**SUBJECT:** REVISED SITE PLAN SKETCH  
REZONING REFERENCE #27/94  
3555 AND PTN. 3719 GILMORE WAY  
DISCOVERY PARKS WILLINGDON  
(B.C.I.T.) COMMUNITY PLAN

**TO:** CITY MANAGER  
**FROM:** DIRECTOR PLANNING AND BUILDING  
**SUBJECT:** REVISED SITE PLAN  
REZONING REFERENCE #27/94  
3555 AND PTN. 3719 GILMORE WAY  
DISCOVERY PARKS (BCIT SITE) COMMUNITY PLAN

**REZONING REFERENCE # 27/94**  
 (HONGKONG BANK SITE) # SKETCH 1

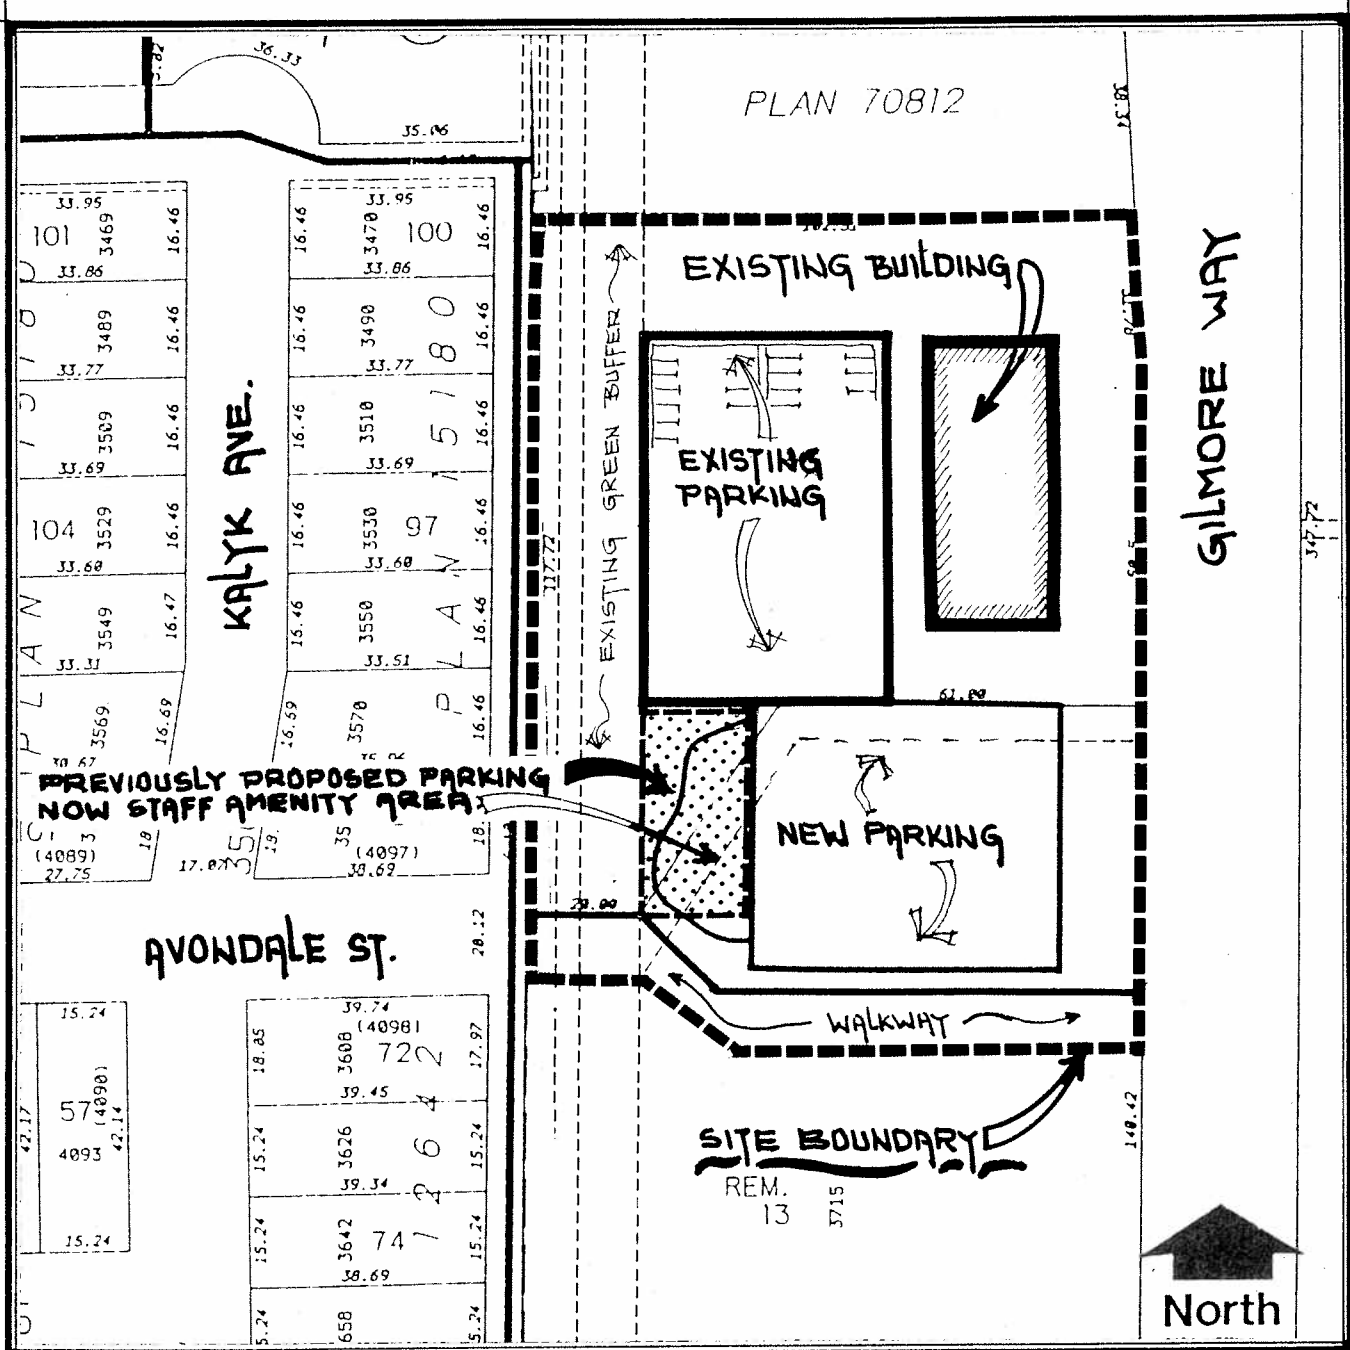
A sketch reflecting the comments made in the 1995 May 15 report is **attached** (see Sketch #1). It indicates the extent of the parking expansion first proposed and now revised, the reduction having been achieved by incorporating small car stalls, as well as the additional landscaped area.
